Rezoning Transportation Analysis

Petition Number: 2018-049

Revision Log:	Date	Description
	05-24-18	First Review
	06-14-18	Second Review
	08-17-18	Third Review

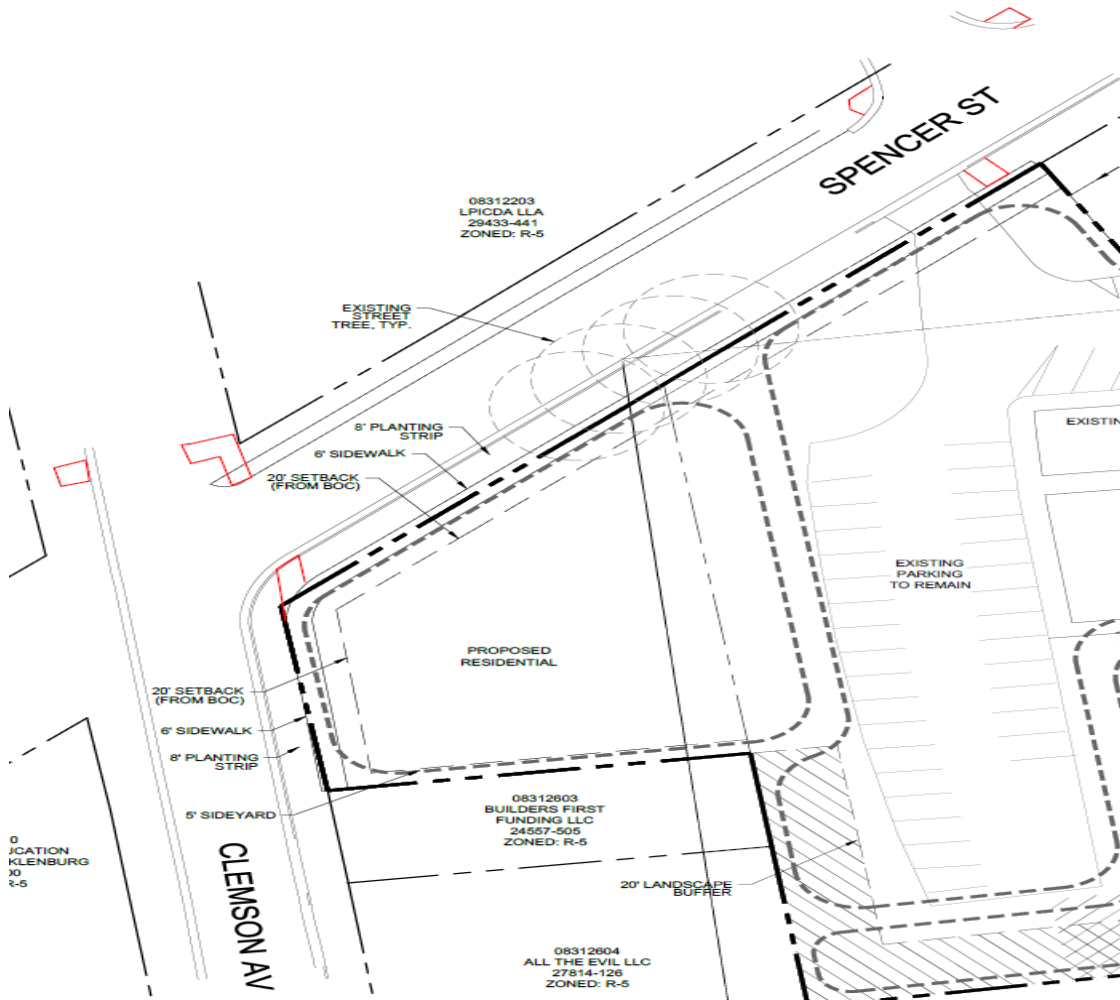
1. ~~**Curbline** The proposed zoning district has a setback measured from back of the existing or proposed future curbline. The existing back-of-curbs are in the correct future location for Charles Avenue, Clemson Avenue, Spencer Street and Whiting Avenue.~~
2. ~~**Traffic Study** A Traffic Impact Study/Transportation Technical Memorandum is not necessary for the complete review of this petition.~~
3. The petitioner should revise the site plan and conditional note(s) to show the proposed sidewalk on Charles Avenue extending to the intersection with Clemson Avenue. This would provide pedestrian access from the proposed development to the Clemson Avenue Park.
4. The petitioner should revise the site plan and conditional notes to show curb ramps at the intersection of Spencer Street and Clemson Avenue and the intersection of East 34th Street and Spencer Street as shown below:
